PRODUCT CHANGE NOTIFICATION

SLIDE POTENTIOMETERS

Structure Improvement for Bourns® Low Profile Slide Potentiometers *Model PTE Series*

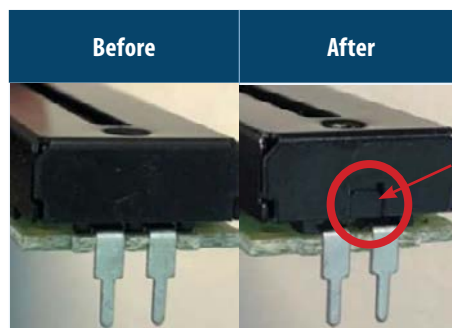
Riverside, California – October 19, 2020 – As part of our continuous improvement efforts, effective December 15, 2020, the structure of the Bourns® [Model PTE Low Profile Slide Potentiometer Series](#) will be enhanced by adding a feature shown in the “After” picture below to prevent the lever from swinging over the limit of the slide during extreme operation. This improvement will eliminate the abnormal clicking sound caused when the lever reaches an end.

The change will affect the form of the product, as depicted below. The fit and function will remain the same. The quality and reliability of the product should improve. With this new structure, there should be no abnormal clicking sound. A list of affected part numbers is included on the next page.
